Item 13.**Section 4.55 Application - 205-213 and 215-225 Euston Road, Alexandria – D/2016/989/B****File No.:** D/2016/989/B**Summary**

Date of Submission:	8 August 2018 Amended plans and information received 15 November, 2 December, 19 December and 20 December 2019
Applicant:	Hailiang Property Group Australia
Architect/Designer:	Silvester Fuller, MHNDUnion and Sue Barnsley Design
Developer:	Hailiang Property Group Australia
Owner:	Maxida International Alexandria Property Australia Pty Ltd
Cost of Works:	\$0
Zoning:	The site is located in the B4 mixed use zone. No change is sought to the approved indicatives uses, that being residential and commercial. These uses are both permissible with consent.
Proposal Summary:	<p>The subject 4.55(2) application seeks to modify the approved concept consent (stage 1), including by way of amending the approved building envelopes and conditions.</p> <p>A detailed development application (D/2018/907) has also been lodged alongside the modification. These applications are being reported simultaneously to CSPC.</p> <p>Clause 4.24 of the Environmental Planning and Assessment Act 1979 requires any subsequent development application to be consistent wit

Figure 29: Proposed level 1 – noting balcony areas are excluded from the plans.

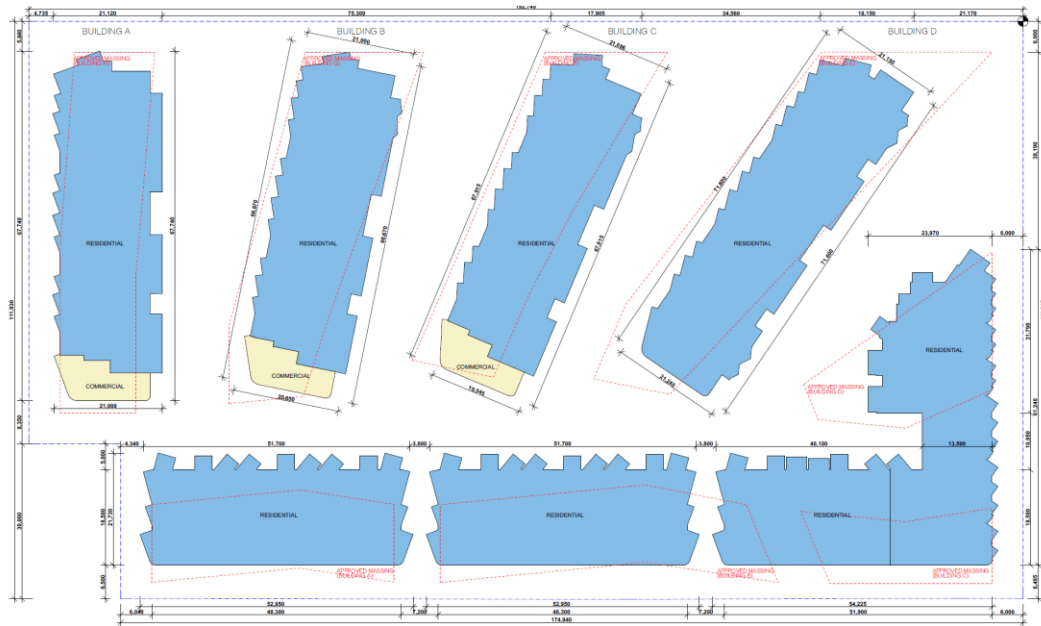
39. There are a number of inconsistencies on the submitted envelope plans. The envelope plans do not show the reduced setbacks to Sydney Park within the building envelopes. The envelope elevations show parts of the reduced setbacks at the upper levels. It appears that the envelopes plans and parts of the elevations have excluded balcony areas, pergolas and architectural structures.

41. Condition 9 of the concept consent requires that the "building envelopes are only approved on the basis that the ultimate building design, including articulation, balconies, services, privacy treatments and other projections will be contained within the approved envelopes." As such, these elements should be contained within the envelopes.

Figure 30: Proposed detailed DA – level 1. The red line indicates the 6m setback from the park boundaries.

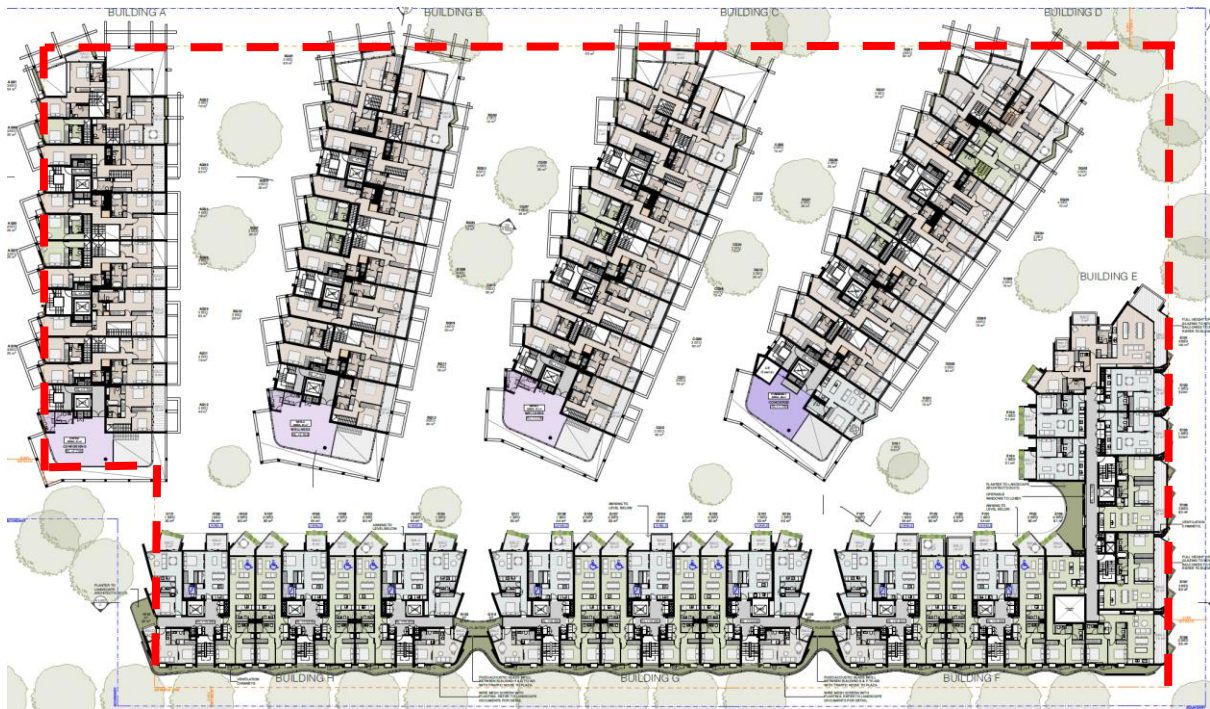
40. A review of the detailed DA plans, D/2018/907, with which these envelope plans are supposed to be consistent (as per the application) show minimum setbacks of 1.5m on the southern boundary and 1.5m on the western boundary.

42. The proposed amended envelopes are shown below. Comparable ground floor and level 1 detailed DA plan is also included to show how much further the envelope would need to extend to accommodate the proposed detailed DA.

Figure 34: South elevation of building H (Parkside building). The blue represents the amended envelope. The yellow line shows the approved concept envelope and the red dashed line shows the 18 metre height limit.

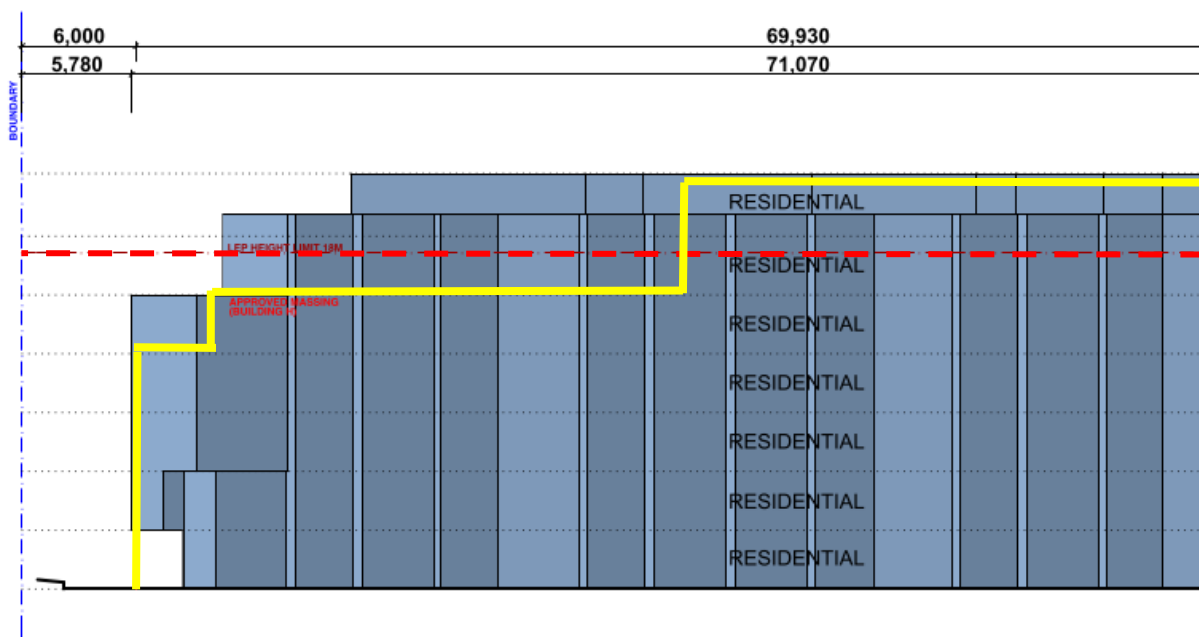
Development Control	Compliance	Comment
4.3 Height of Buildings	No	<p>A maximum height of 18m is permitted.</p> <p>A maximum height of 25.95 metres (or RL 30.55) is proposed. This represents a 44% variation above the base development standard and a 49% departure from the existing approved height. This is discussed further in the issues section below.</p>

Figure 44: Comparison of approved (white) and amended (red) massing showing how the Parkside buildings and Euston Road buildings are taller, protruding closer to the boundaries and will be more visible from Sydney Park.

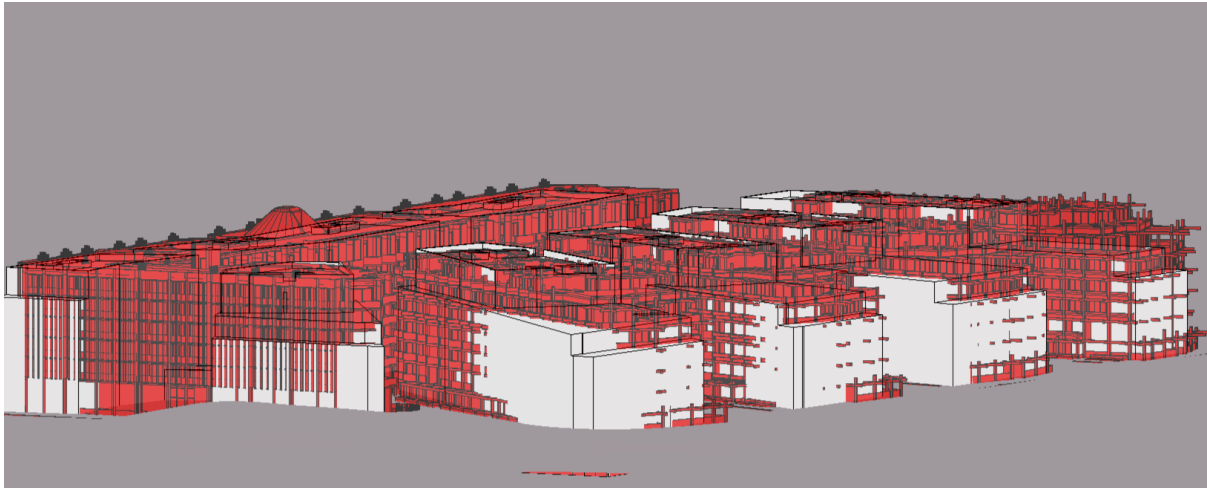
71. The original approval allowed a clause 4.6 variation which moved height to the eastern side of the site away from the Park. This was supported as it results in a better transition from landscape (Sydney Park) to urban (Euston Road) setting.

72. This objective is undermined by the proposed modification as building height is increased across the site. In particular on the Park side of the development. The current approval includes a 4, 5 and 6 storey stepped form increasing in height as the envelopes transition away from the Park. It is proposed to not only bring the envelope closer to the park boundary, but to also increase the height to a 5, 6 and 7 storey stepped form. In addition, very little delineation is provided between the lower park side buildings and the taller eastern (Euston Road) buildings. This is discussed further under the heading, 'height' below.

Figure 46: Comparison of approved (white) and amended (red) massing showing how building H is taller and closer to the south and west boundaries.

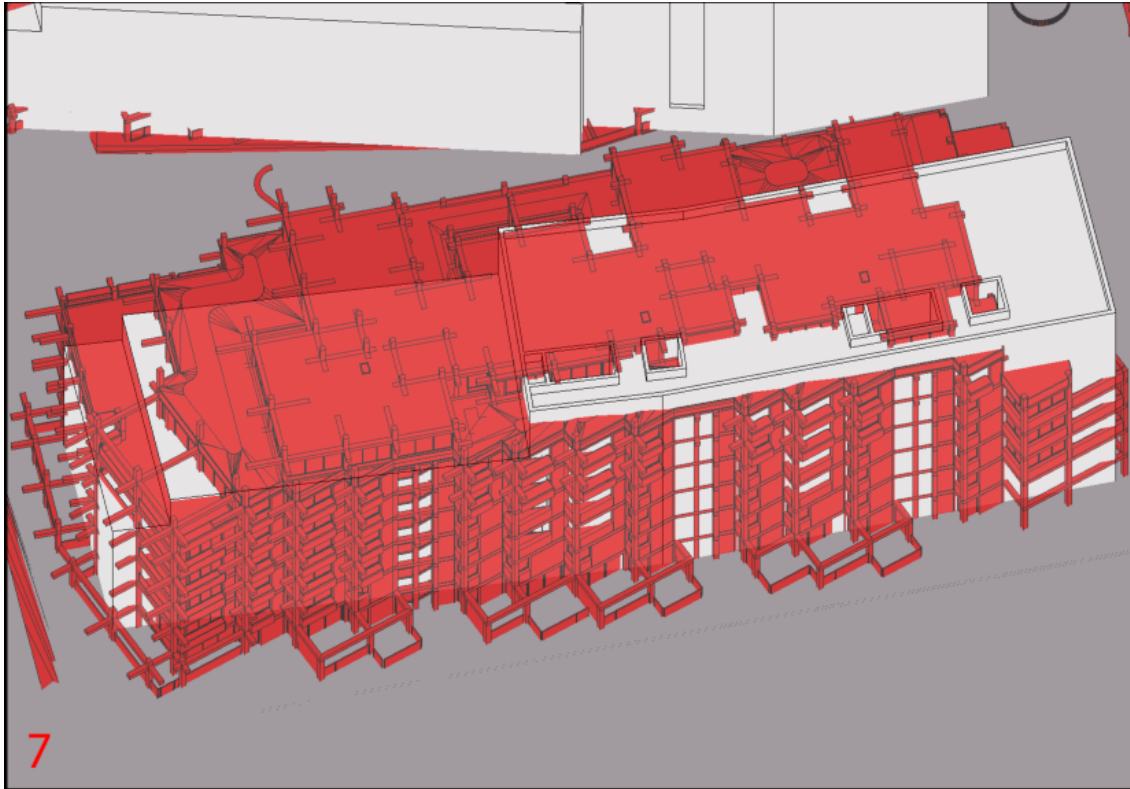
87. The proposed amendment seeks to reduce the southern ground floor setbacks to 1.5 metres, and the western ground floor setback to between 1.5metres and 3.5metres. This is shown in the figures below.

Figure 47: Relationship between buildings A, G and H showing how amended envelope (red) is taller and closer across the plaza than the approved envelope (white).

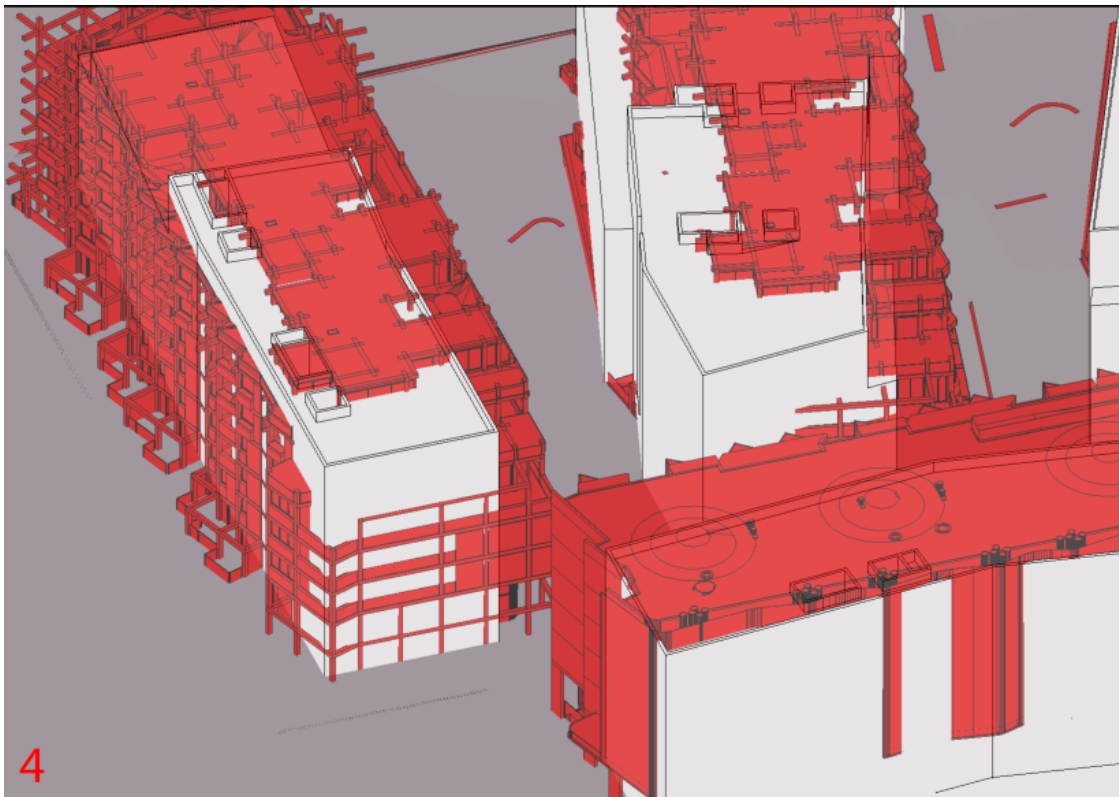
103. The proposed modification does not provide the minimum 18 metres separation distance. The buildings are now proposed to be a minimum of 8.6 metres apart. This is shown in the figures below.
104. These non-compliances will result in acoustic and visual privacy issues, and results in a narrowed, more enclosed plaza. This non-compliance is not considered acceptable.

Figure 48: Proposed ground floor of building H located on the southern side of site adjoining Sydney Park. This shows the reduced setback to the southern and western boundaries.

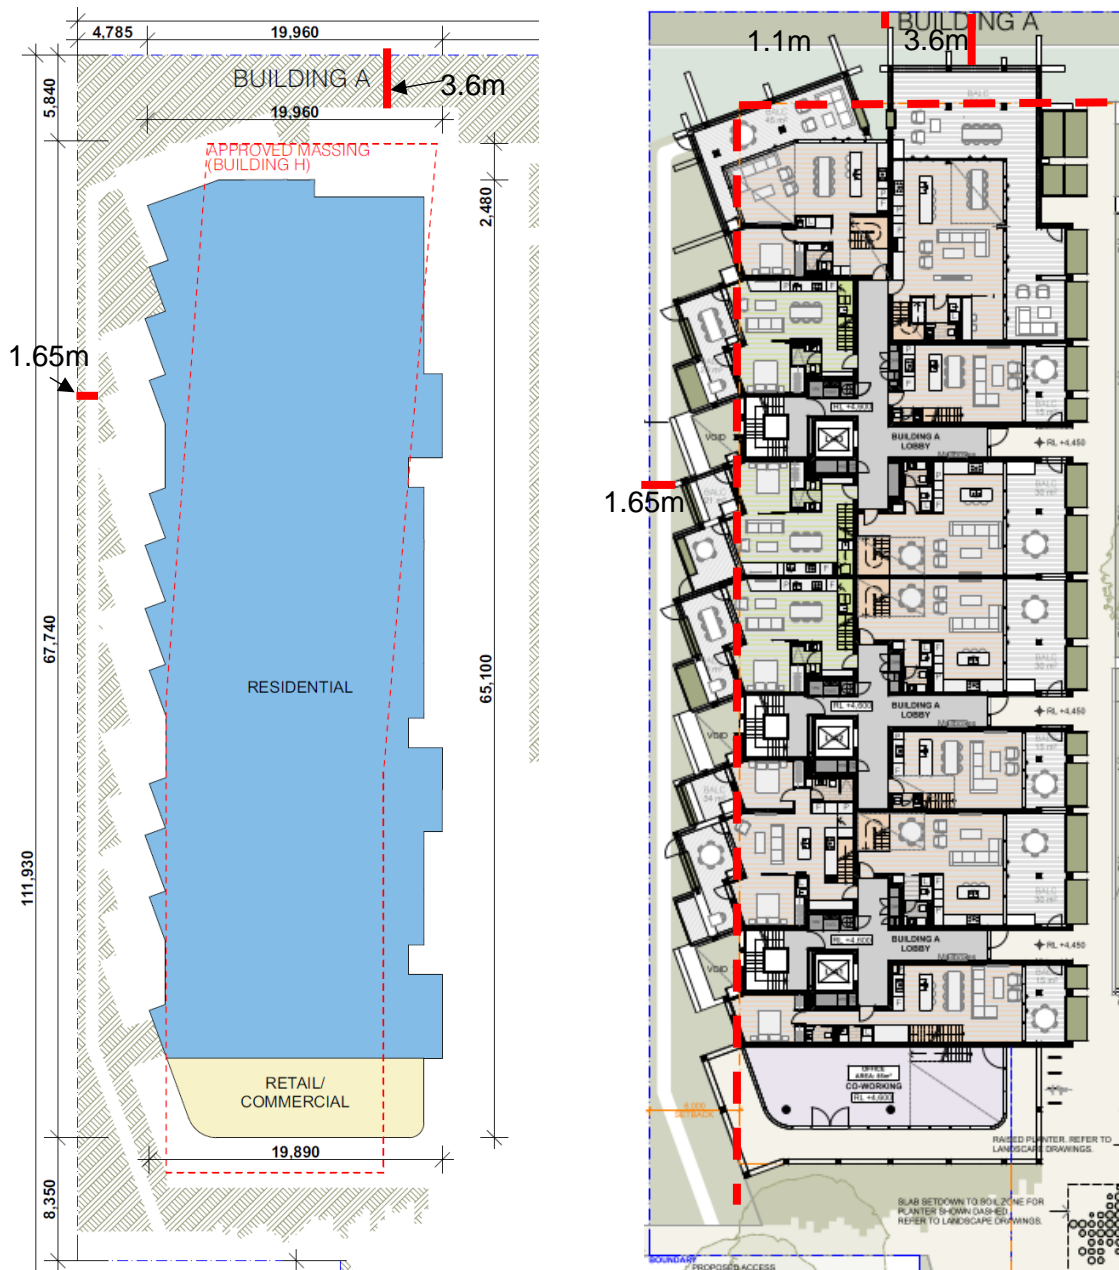
"A minimum 6m setback, below ground and above ground, shall be incorporated into the buildings envelopes at all Sydney Park boundaries to provide the existing trees within Sydney Park the ability to continue to establish without being impeded by proposed structures or adversely impacted by building construction and ongoing building use. The increased setback must allow for an improved and substantially vegetated interface with Sydney Park including trees."

Figure 54: Shadow diagram at 12pm. Orange shows additional shadow and green shows shadow reduction. This plan does not include balconies, pergolas or additional structures.

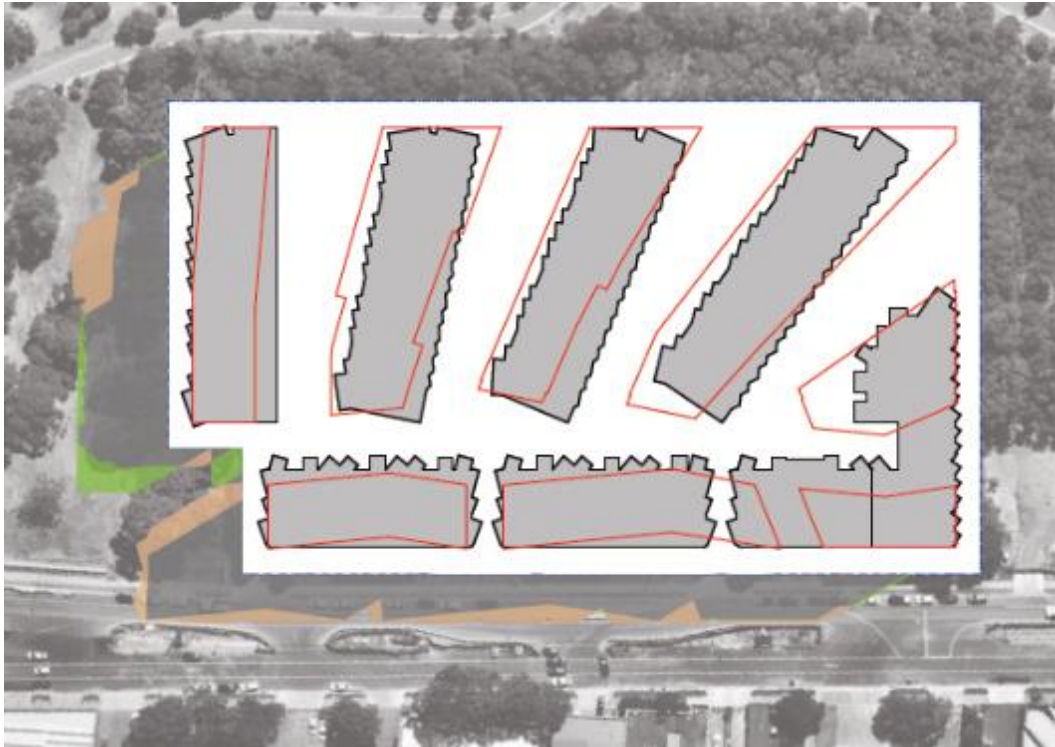
91. This development is located in a very sensitive area where any additional height and bulk will be readily perceivable. The modified envelope will visually and spatially encroach further into the park and result in additional overshadowing when compared to the approved massing. This does not constitute design excellence and results in a substantially different envelope.

93. The areas marked in orange on the following plans show the additional shadow created as a consequence of the additional height and bulk added to the envelope, and the reduced setbacks. The green shows a reduction in shadow, caused by the adjustment of the position and massing of the Parkside bindings. Figure 56 includes a photo of the area in the park that will be overshadowed as a consequence of the changes to the envelope.
